SUBJECT: Addendum 1- RFP #21-06 BRT Fare Collection System

**RFP #21-06 FARE COLLECTION SYSTEM
QUESTIONS & RESPONSES**

INSTL-PROVISION, SMART CARD	
SCALE 1:116	PART N° 866235
SHEET 1 OF 1

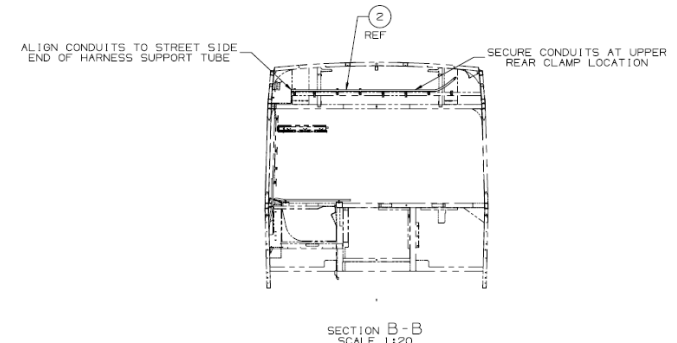
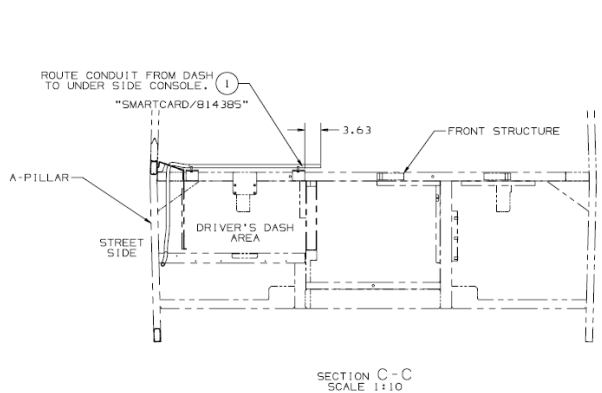
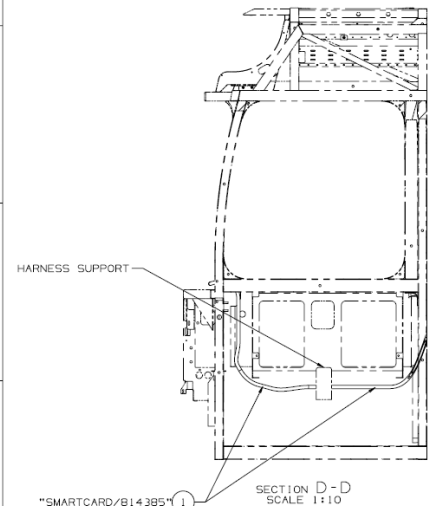
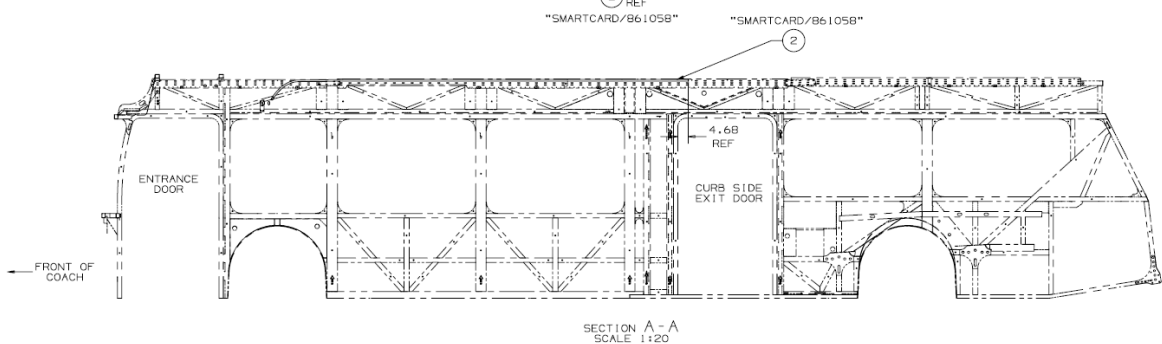
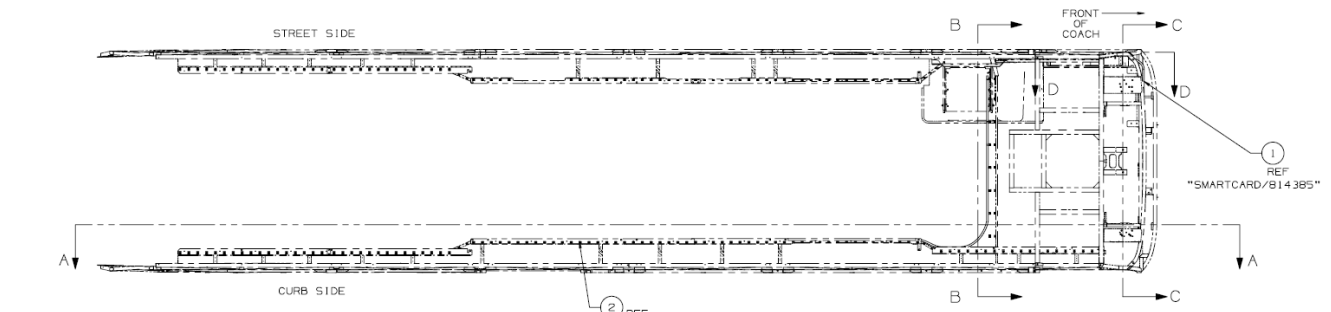
NO.	SOLICITATION REFERENCE	COMMENTS / QUESTIONS	RESPONSE	DATE RECEIVED	ANSWERED IN ADDENDUM
17	Request for Proposal	Will BJCTA accept this as an alternative approach for this feature requirement?	In the event that proposers submit an alternative approach, they should include any exceptions in their proposals.	3/05/2021	01
18	Request for Proposal	Please confirm that the integration will take place between back-end systems and that a cable/connection between the validator and CAD/AVL system is not required on board	Contractors should provide how this integration will take place in their proposals.	3/05/2021	01
19	Request for Proposal	Please provide the make and model for all bus types where validators are to be installed as well as any available schematics or photos of on-board installation points.	Model: New Flyer XN40 Bus. See attached Schematic and Photo on pages 14 , 15 and 16	3/05/2021	01

Validators will be placed in Circled Area
